Merged Document Report

Application No.: PL9249

Description :	
Address :	
Record Type :	PLAT

PLAT OF ROGER'S SUBDIVISION BLOCK 1, LOTS 1CA AND 1CB

PLAT OF
ROGER'S SUBDIVISION
BLOCK 1, LOTS 1CA AND 1CB

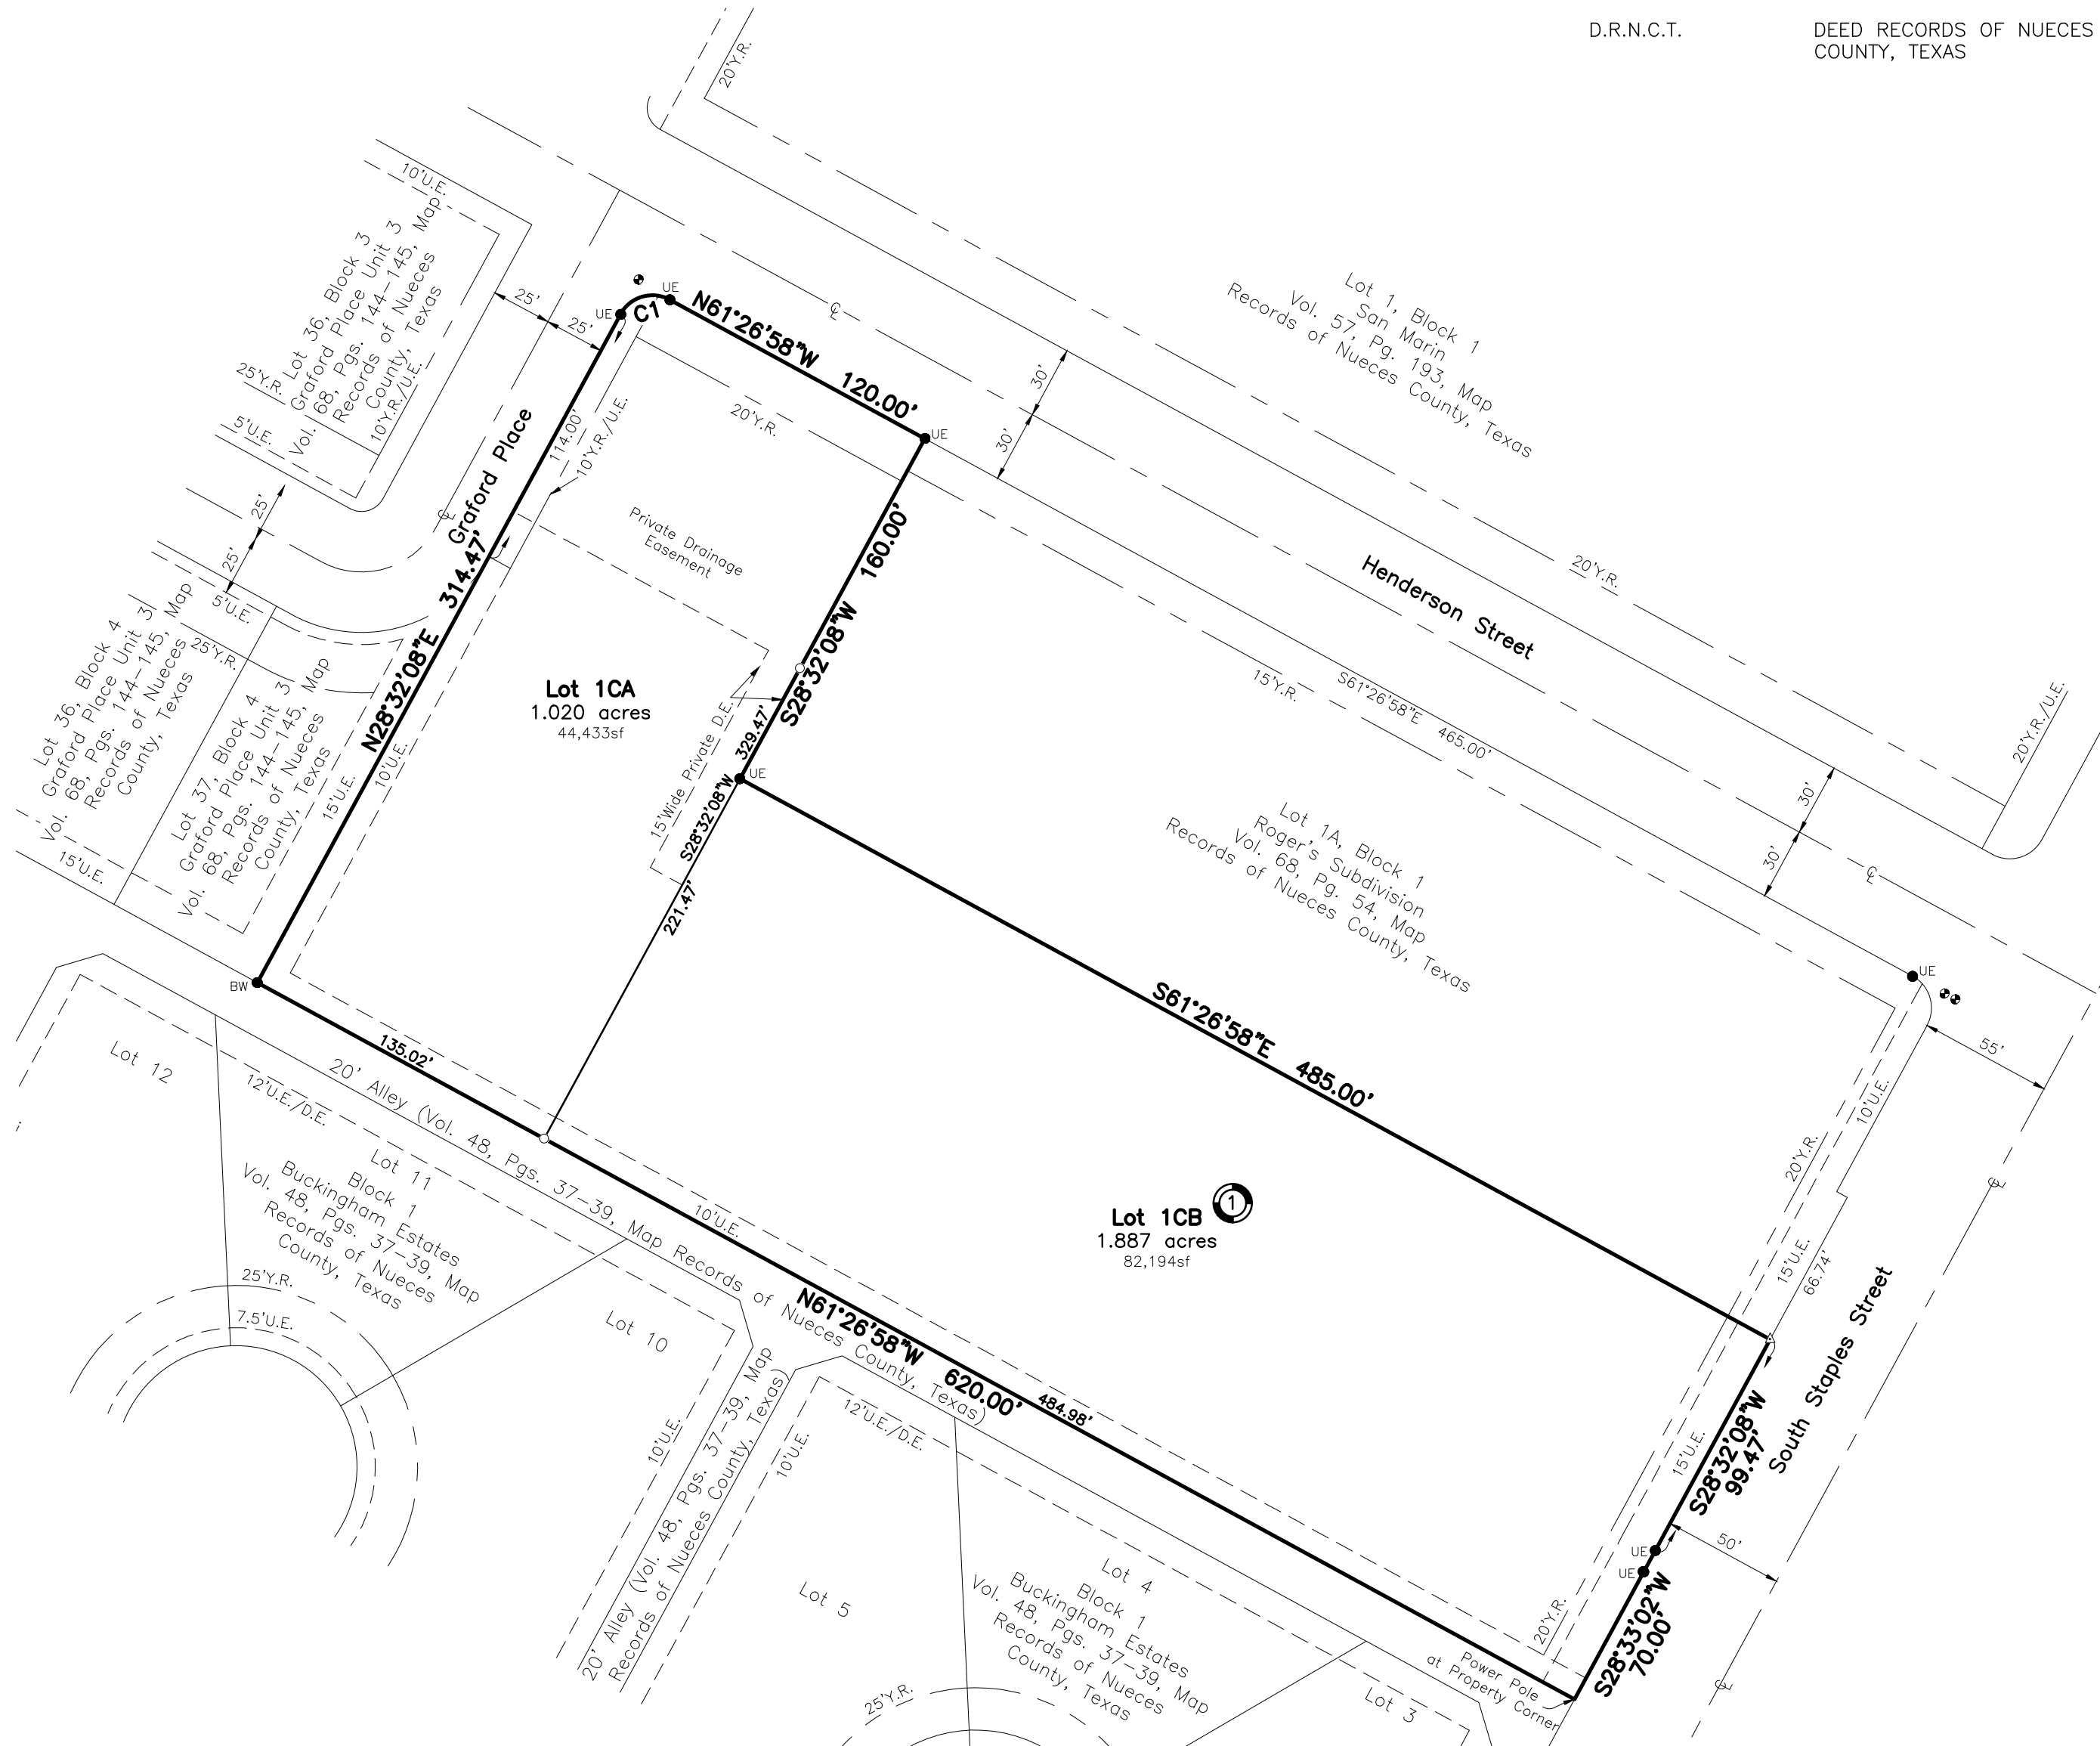
7	P001	Note	Bria Whitmire : DS	Closed	<p>Drainage Easement needs to be shown if planned. Refer to SWQMP comment for more information.</p>	
8	P001	Note	Bria Whitmire : DS	Closed	<p>Driveway Permits (sizing and spacing) and ROW Permits (any work in ROW including utility tie-ins) to be obtained from Public Works at Link</p>	
9	P001	Note	Bria Whitmire : DS	Closed	<p>M.R.N.C.T. and D.R.N.C.T. double listed in legend</p>	
1	P001	Note	Mark Zans : LD	Closed	<p>Change director to Interim Asst. City Manager</p>	
2	P001	Note	Mark Zans : LD	Closed	<p>Fire comments #1</p> <p>Please see Fire's Comments PL9249 Roger's Subdivision Block 1 Lots 1CA & 1CB</p> <p>Note: All code reference is based on currently adopted International Fire Code (IFC) 2021 and Corpus Christi Water Distribution Standards.</p> <p>"Commercial Development shall have a fire flow of 1,500 GPM with 20 psi residual. Fire hydrant every 300 feet and operational."</p> <p>507.5.1 (amendment) Where Required: All premises, other than one-family detached dwellings, where buildings or portions of buildings are located more than 150 feet from a fire hydrant shall be provided with approved on-site hydrants and water mains capable of supplying the fire flow</p>

12	P001	Note	Mark Zans : LD	Closed	If WW line easement is required along this property line, then please reflect on the plat and label width and use type.	
14	P001	Note	Mark Zans : LD	Closed	Astound Underground facilities: Astound does have underground facilities in an easement along Graford Road. Please place these faculties in and easement and reflect that easement on the plat.
